Republic of the Philippines
 Department of Justice
BUREAU OF CORRECTIONS
NEW BILIBID PRISON
 Muntinlupa City

SUPPLEMENTAL BID BULLETIN NO. 1

**CONSTRUCTION OF LEGAL HEARING FACILITY WITH RELATED
 EQUIPMENT AT SABLAYAN PRISON AND PENAL FARM (SPPF)
 ITB NO. 2026-009a
 28 April 2026**

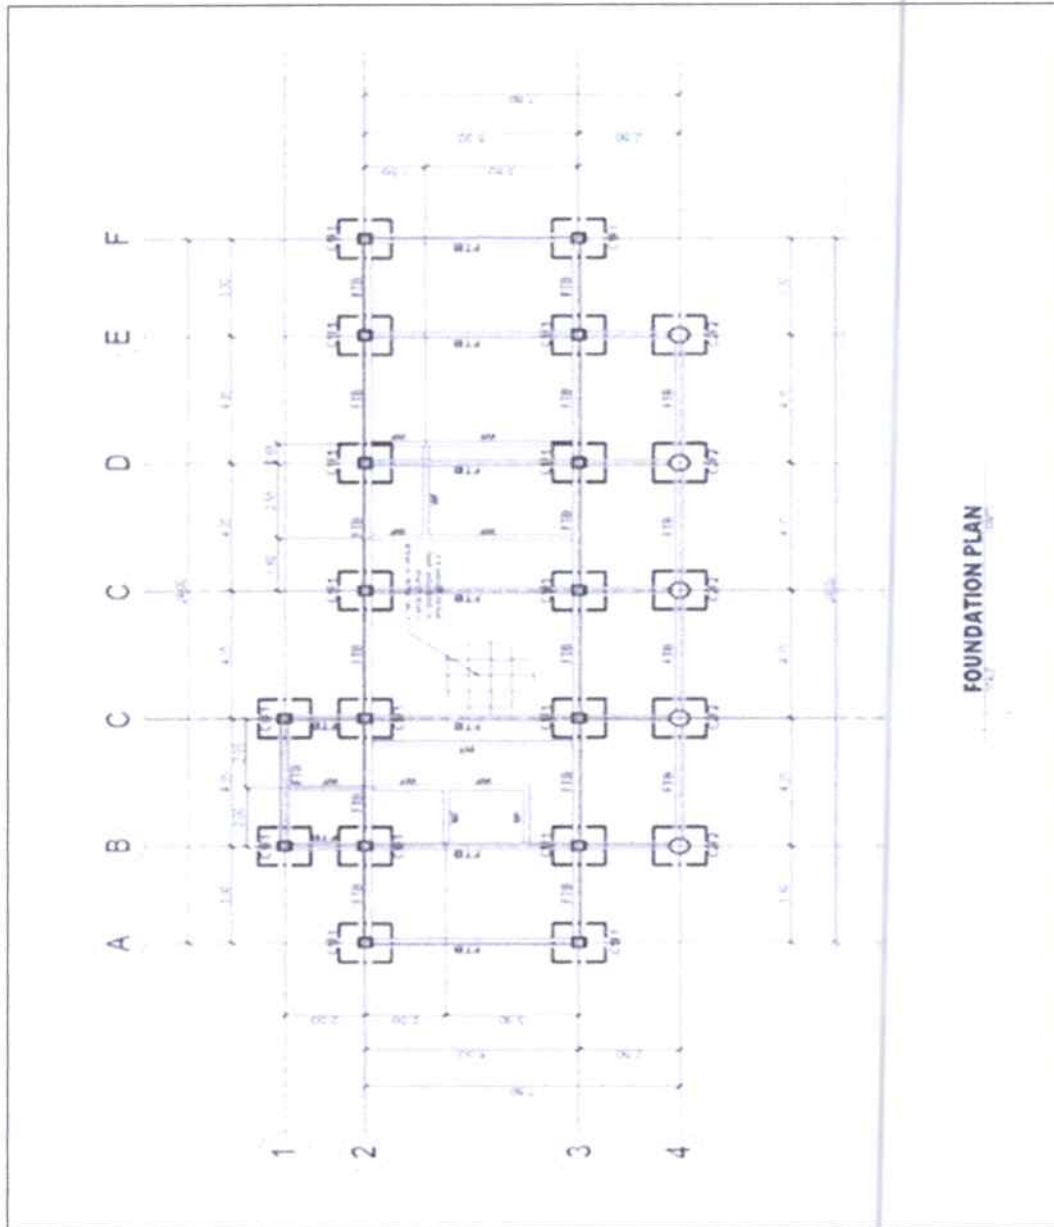
3. Column C-2 Reinforcement (S-3):

The plan specifies 8-16mm vertical bars with circular ties spaced at 75mm (SJ) and 150mm at plan. However, the reinforcement quantity and tie spacing differ from the section detail below C-2. Kindly confirm the correct detailing.

Please refer to below details: Column Footing Detail.

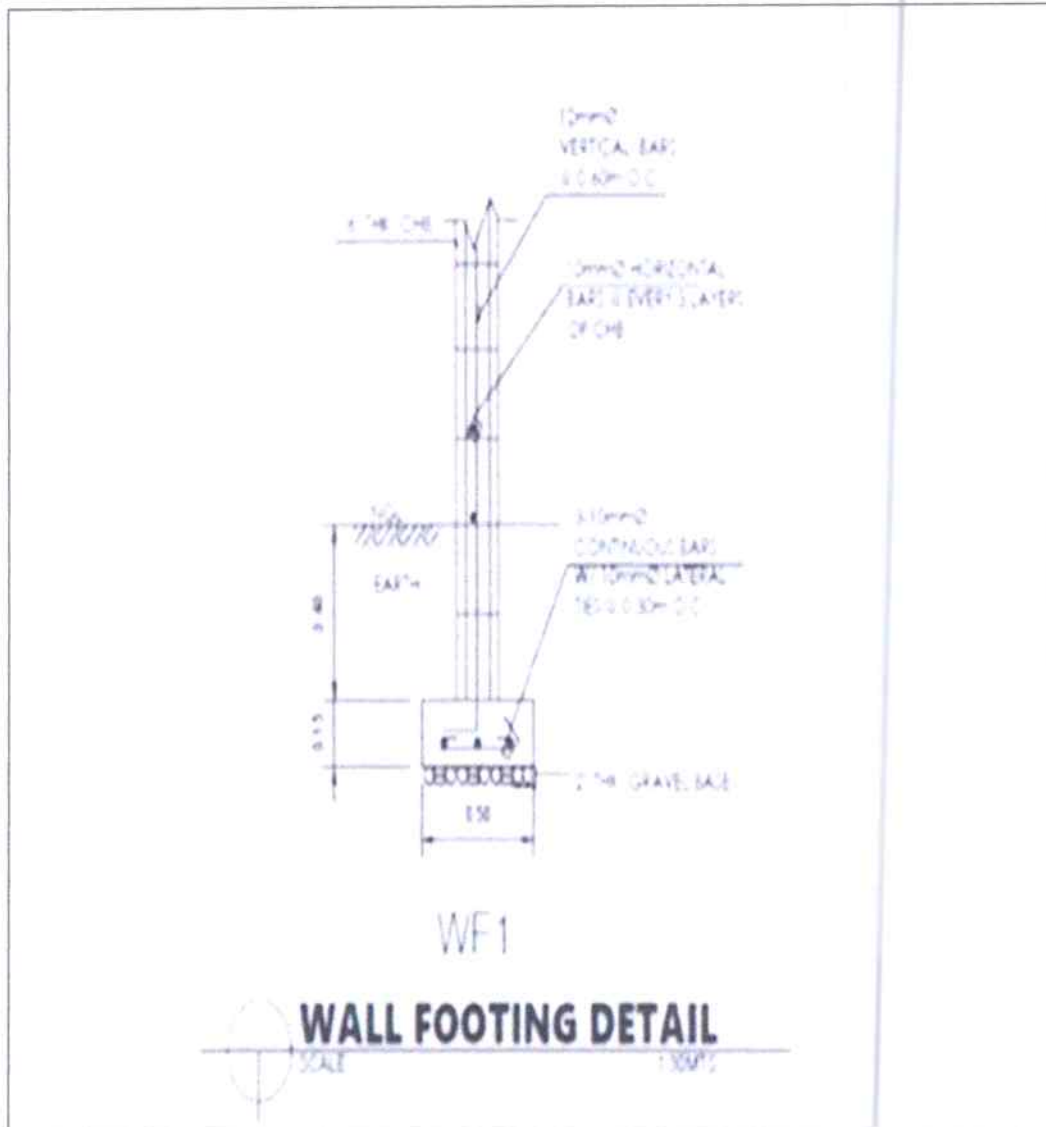
Query/Clarifications	Response/Answer
<p>6. Masonry Works Reinforcement:</p> <p>The Scope of Works specifies Grade 60 reinforcement, while Structural Plan (S-4) indicates the following:</p> <ul style="list-style-type: none"> • CHB 6: 10mm @ 400mm (vertical), 10mm @ 600mm (horizontal) • CHB 4: 10mm @ 400mm (vertical), 10mm @ 600mm (horizontal) 	<p>Please use Grade 40 reinforcement for masonry works.</p>
<p>7. Wall Footing Details Discrepancy</p> <p>Structural Plan S-7 shows continuous bars of 3-12mm with lateral ties at 300mm O.C., while S-1 (Typical CHB Footing) indicates 3-10mm with the same spacing. Kindly confirms the correct specification.</p>	<p>Please use 10mm diameter reinforcing bar, as this size was used in the quantity take-off.</p>

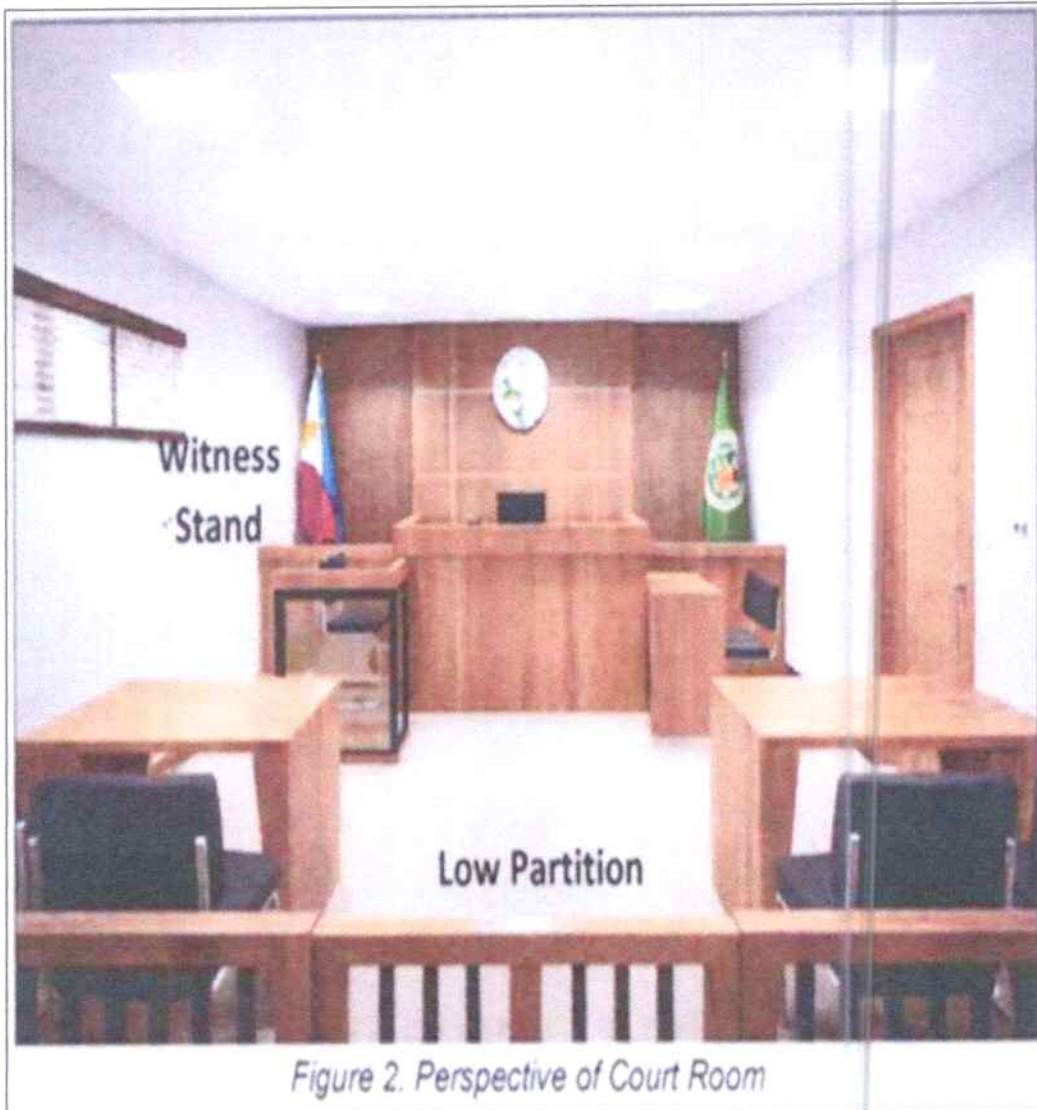
Query/Clarifications	Response/Answer
<p>11. Stainless Steel Letters and Logos Detailed dimensions, specifications, and connection details.</p>	<p>Only the letters will be stainless steel while Logos will be painted finish. The width of the letters must be proportionate with the height, as follows;</p> <p>a. DEPARTMENT OF JUSTICE - 0.24m ht.; Depth = 0.03m</p> <p>b. BUCOR-0.41m ht.; D=0.05m</p> <p>c. COURT BUILDING -0.29m ht.; 0.04m</p> <p>d. Thickness of Stainless-Steel Plates shall be 3mm thick.</p> <p><i>Contractor to introduce methods for mounting the letters on the parapet wall.</i></p>
<p>12. Tempered Glass (CourtRoom) Detailed dimensions for tempered glass installations.</p>	<p>Tempered Glass is for the witness stand. Placed with Wooden Top Rail and base.</p>

Figure 3. Furniture Plan

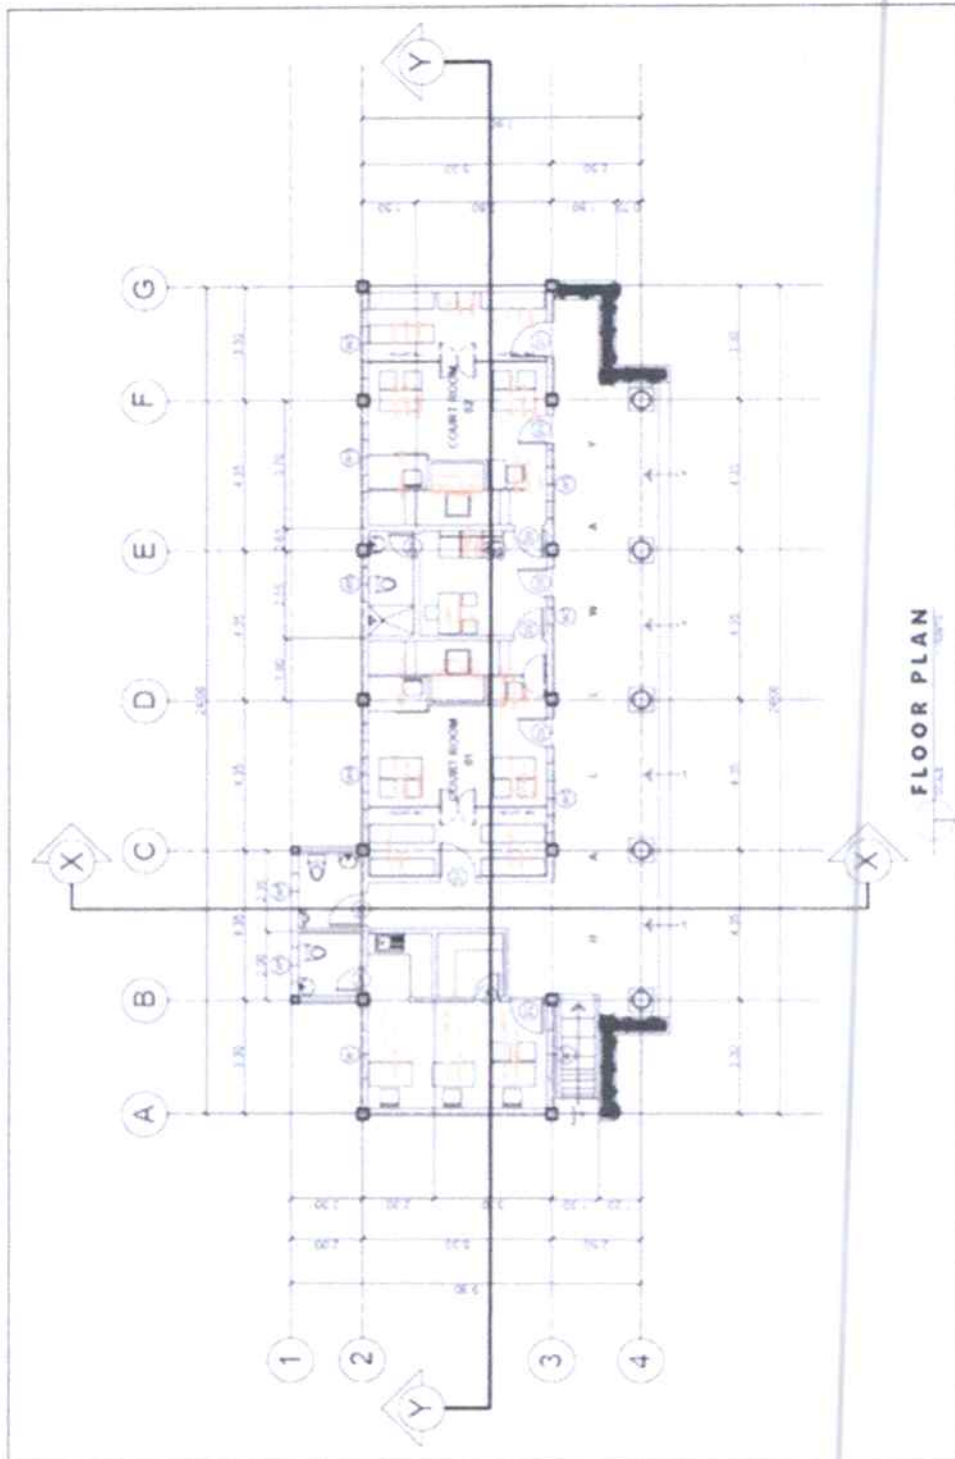
Query/Clarifications	Response/Answer
<p>13. Upholstered Sofa</p> <p>Detailed dimensions of Sofa</p>	<p>Sofa's Dimension — 0.8m W x 1.8m L</p>
<p>14. Furniture and Accessories Scope</p> <p>Clarification whether the quantities and specifications under “Furniture and Other Accessories” in the Scope of Works are included in the contract, or if the furniture shown in the floor plans shall be considered.</p>	<p>Yes, all furniture items are included in the Detailed Estimate, although they are quantified on a lump sum basis. Please refer to the figure below for guidance.</p>

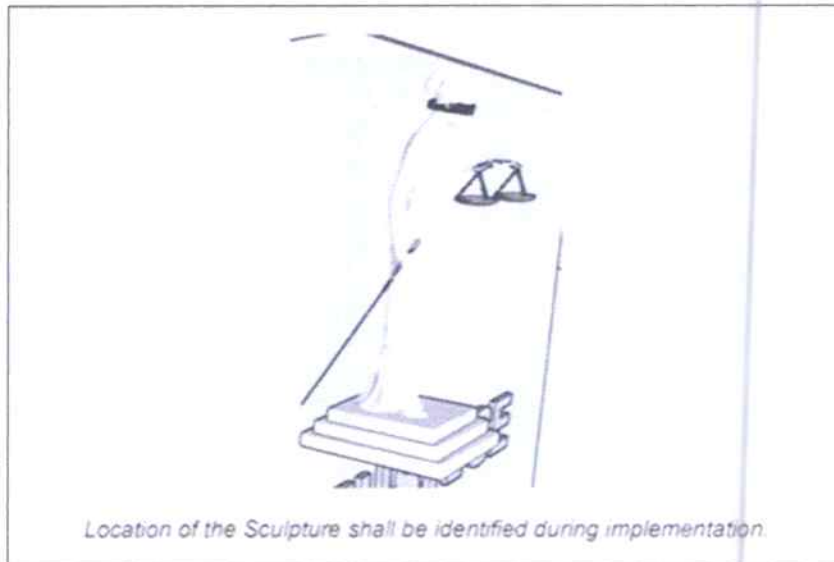
Query/Clarifications	Response/Answer
<p>15. Lady Justice Sculpture</p> <p>To clarify the required Specifications, particularly whether the finish shall be painted or otherwise specified.</p>	<p>Lady Justice Sculpture is included in the Detailed Estimate together with the Stainless Steel Letters quantified on a lump-sum basis under item in "Furniture and Accessories Scope". This shall be stainless Steel with dimensions as follows:</p> <ul style="list-style-type: none"> • Height - 1.46m • Width - 0.35m • Depth - 0.3m
